Courtyard enclosure study · closing the conditioned house around the open courtyard · Taif / Palm House V7.1

Design review Y-01 (critical) · 30 Oct 2026 · the windows follow `docs/DESIGN_LANGUAGE.md` (black steel, divided lites)

DECIDED: option A (owner, 30 Oct 2026, applied in V7.0): the projection 1.55 m, B3 / R11 / C21–C23 at x 5.80, W1 / W2 / W3 as in § 2. The "now" column below is the V6.3 state (edge x 5.60), kept as the record of the comparison.

Plans of the gallery strip, first floor · now / A / B · the sky opening and the void · about 1:115 on A4

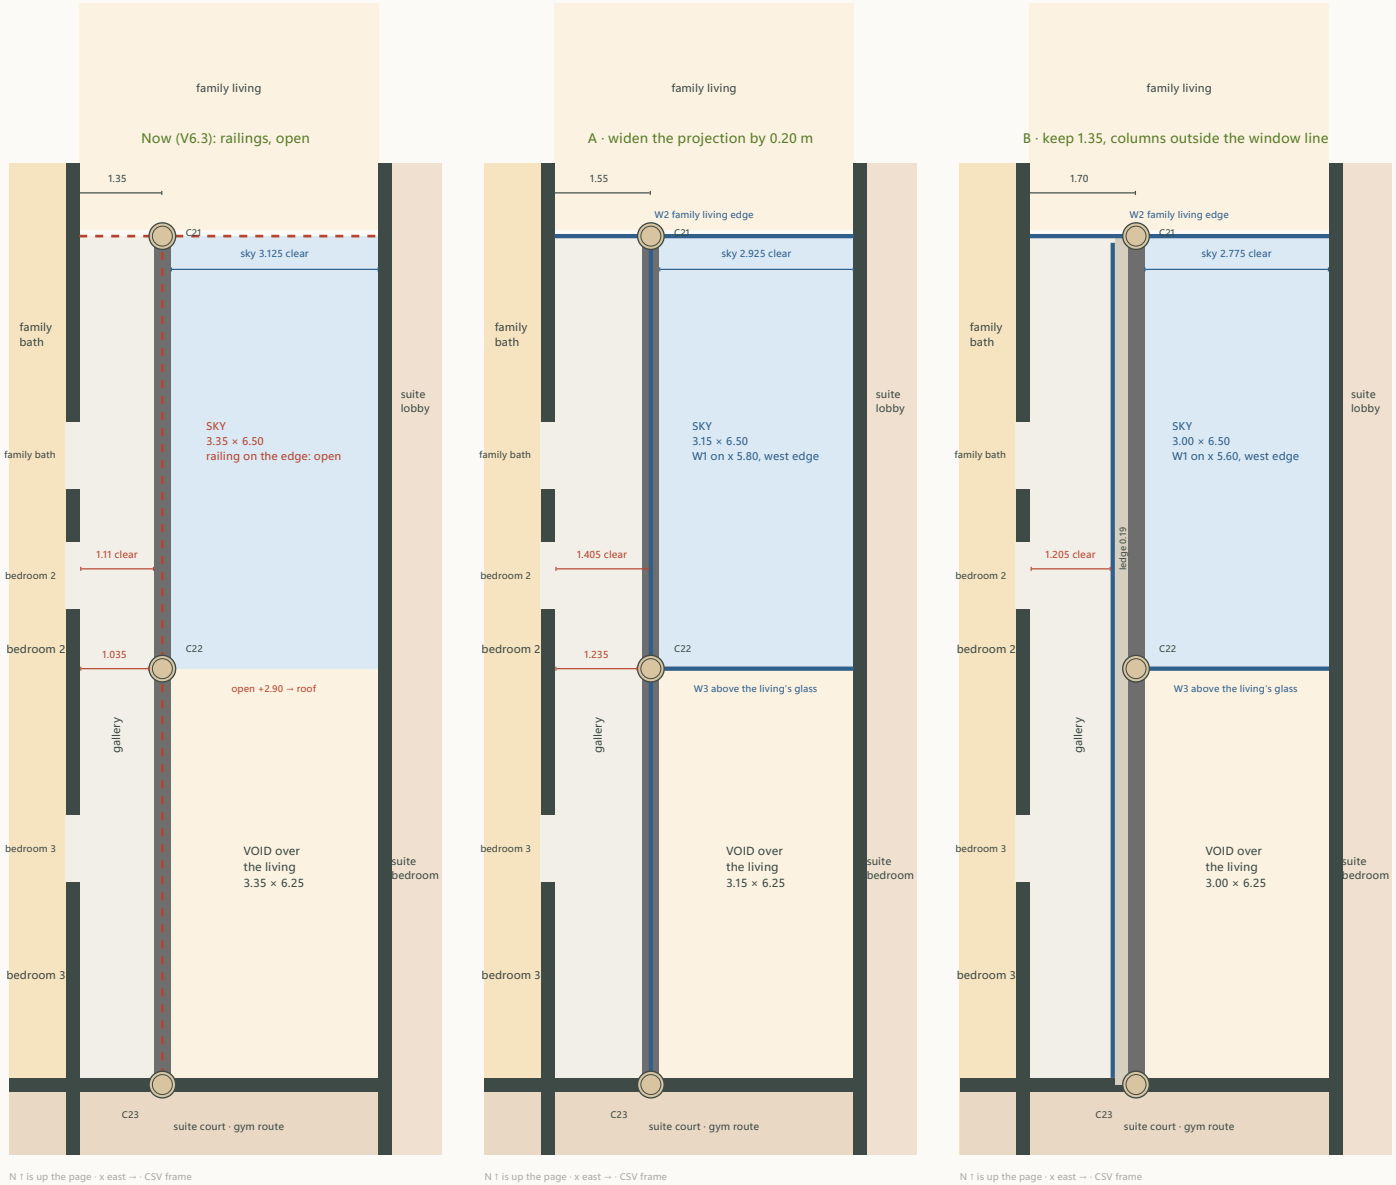
Today the gallery is 1.11 m clear between the rooms' finished wall face (x 4.365) and the upstand of B3, and 1.035 m at the three stone column sleeves (Ø0.4). A window on the line changes little by itself; the columns are the problem. Two ways to reach 1.20 m:

4 · Recommendation: A **A** keeps everything on one line: the beam, the columns, the window and the railing base are the same element, the gallery is 1.405 m clear and 1.235 m at the columns, the sky loses 6 % of its area and stays 3.15 m wide on axes. **B** reaches 1.20 m with no margin (1.205 m), narrows the sky more (3 m: the beam and the roof edge must follow the columns), and adds a 0.35 m ledge outside the glass that must be waterproofed, capped and kept clean; its one real gain, free-standing columns in front of a glass wall, is a stronger colonnade image. If the owner wants that image, B is buildable; otherwise A. In both, the two-storey columns, the upturned B3 and R11 stay as decided (X8); only their x changes. **Study checks passed** (7)

Sections through the courtyard (y ≈ 10, looking north) · A and B · about 1:105 on A4

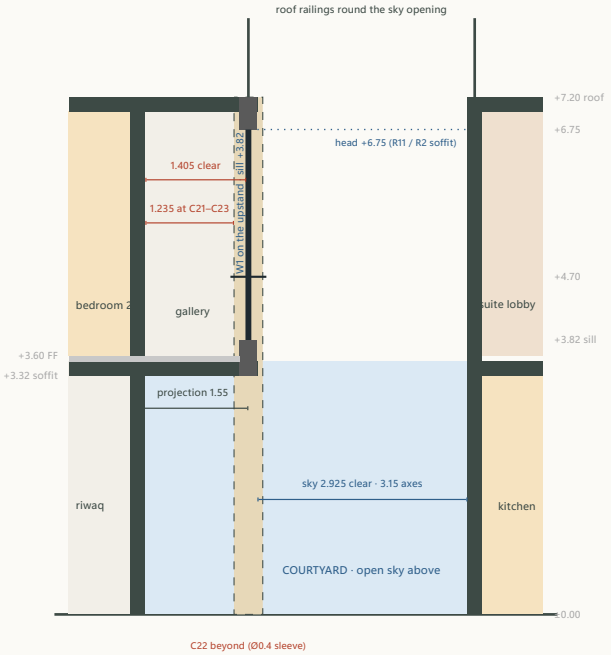
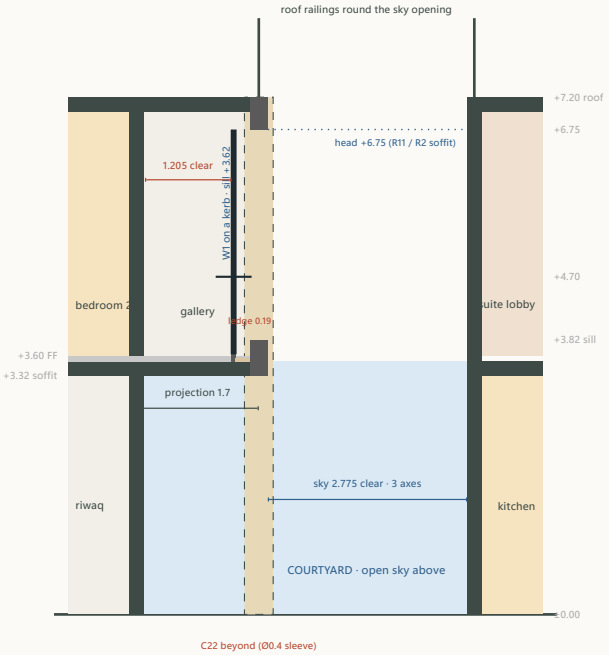
Both options. W1 bears on the upstand of B3 (the window's dead load is small; the upstand becomes its sill and its anchor, 0.25 wide); W2 on B2 (floor-level sill, the frame anchored to the slab edge and R1); W3 spans +2.90 → +6.75 between C22 and the kitchen wall, held top and bottom (R2 above; a steel transom at +3.82 tied to C22 and the wall takes the wind of the 3.85 m height; the courtyard well has little wind). The head line is the soffit of R1 / R2 / R11 at +6.75 over the void (y 13–19.25) a 0.25 m fascia keeps the same line under the roof slab. Nothing new for the engineer except the window anchors and, in B, the ledge.

- **A:** B3, R11 and C21–C23 move 0.20 m east to x 5.8 the projection slab bay becomes 1.55 m (slabs-ff row "the projection"), the roof strip over the gallery 1.55 m (slabs-roof); C22 stays the pier in the living's courtyard glass (now at x 5.8), C21 in the women's majlis glass, C23 in the living's south wall; the spans (6.5 / 6.25) are unchanged, R2's west end lands on C22 at x 5.8. The sky opening is 3.15 × 6.5 m.

- **B:** B3, R11 and C21–C23 move 0.35 m east to x 5.95 the slab bay becomes 1.7 m with the window line 0.35 m inboard of the beam on a 0.10 m kerb; the ledge between the kerb and the upstand is waterproofed and capped (stone, falling out). The columns stand free in the courtyard and in the void: C22 is a free column in the living's courtyard glass line, 0.35 m in front of the upper window W3 (W3 then runs behind it, from the W1 line at x 5.6 to the kitchen wall, 3.25 m). Alternative B2 (not recommended): B3 stays at x 5.6 and reaches the columns at x 5.95 on short corbels; two lines of concrete for one edge.

W1 · the gallery line seen from the courtyard and the void (looking west) · option A · 1:70 on A4

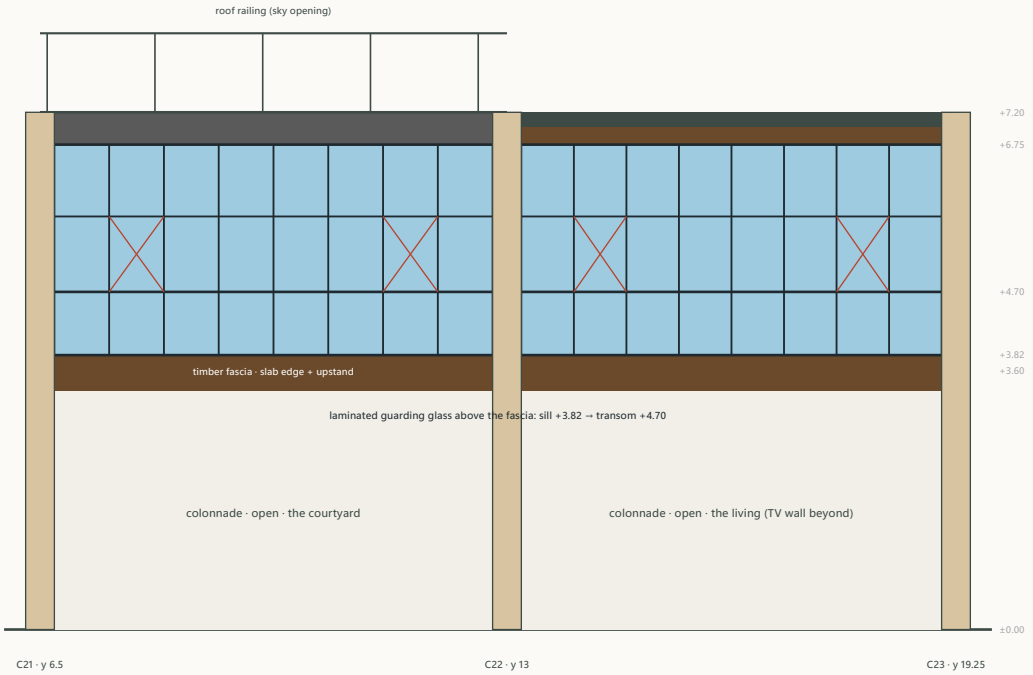
V7.1 (owner, 31 Oct 2026): semicircular heads and the courtyard arcade. Every enclosure window gets a semicircular (Roman) arched head in black steel with divided lites, the arched head fixed, the rectangular part below with the operable lites; the sill and the guarding transom (+4.70) as in § 2. **W1:** six arched windows 1.60 m wide on the gallery edge, three per column bay, sill +3.82, springing +5.80, crown +6.60, 0.15 m of wall below the R11 / R2 soffit (+6.75): in the courtyard bay they stand over the three bays of the new arcade (y 6.783–8.383, 8.950–10.550, 11.117–12.717), in the void bay on three equal bays (13.242–14.842, 15.325–16.925, 17.408–19.008); the four casements sit in the lower parts. **W2:** two arched windows 1.30 m wide east of C21 (x 6.00–7.30 and 7.55–8.85), floor to the crown +6.60, springing +5.95; the strip x 4.25–5.80 of that edge is the family living's opening to the gallery's north end, no window. **W3:** one arched window 2.80 m wide (the whole space between C22's stone sleeve and the east wall; the brief said ≈ 3.0) over the living's courtyard glass, +3.32 to the crown +6.60, springing +5.20, the two motorised tilt lites in its lower part; 0.15 m of wall to the R2 soffit. **The arcade:** in the courtyard bay only, two slender honey-stone columns Ø0.25 on x 5.80 at y 8.667 and 10.833 (three equal bays of 2.167 m on axes) with three semicircular arch plates under the projection's soffit (+3.27): spans 1.84 / 1.92 / 1.84 m between the sleeves, springing +2.35 / +2.31 / +2.35, crown +3.27; decorative unless the engineer uses the columns (`studies/structure.typ` X18); the living bay keeps no arches. The columns stand 0.78 m clear of the sunken seating's west edge, 1.36 m clear of the riwaq door's swing line, 1.33 m from the riwaq glass face; the malqaf outlet is on the east wall. The courtyard reads as a two-tier arcade: three arches below, three arched windows above.

Window	Line	Sill	Head	Lites and operation
W1 gallery edge	x 5.8 (A) / 5.6 (B), y 6.5–19.25	+3.82 (upstand)	+6.75	guarding transom at +4.70 (1.10 above the floor), laminated glass below it; above it lites ≈ 0.75 wide; one inward side-hung casement per bay (two bays, four casements) for calm nights and cleaning
W2 family living edge	y 6.5, x 4.25–8.95	+3.60 (floor)	+6.75	same transom at +4.70, laminated below; two inward casements; no door (the courtyard is reached from the ground floor)
W3 living, upper courtyard side	y 13, C22 → x 8.95	+2.90 (the glass head) or ±0.00 if the ground-floor glass is remade as one steel wall	+6.75	transoms at +2.90 and +3.82 (the gallery's sill line), lites ≈ 0.75 wide; two motorised bottom-hung tilt lites at +3.82–+5.40 for the night mode

Cleaning from inside. W1: both faces from the gallery: the inside directly, the outside through the open casements (every lite within an arm's reach of a casement, the glass height 2.93 m). W2: as W1 from the family living. W3: the inside from the living floor with a water-fed pole (top +6.75); the outside from the courtyard floor with the same pole (6.75 m) or from the gallery's casement at its west end. The courtyard floor's hose point (Y-04) serves the pole. **Frames.** Black steel, thermally broken, divided lites, double low-e glass, dust seals, insect screens on the casements. Depth ≈ 0.06 m on the line; the stone column sleeves stop at the frame with a sealed joint (A) or stand free (B).
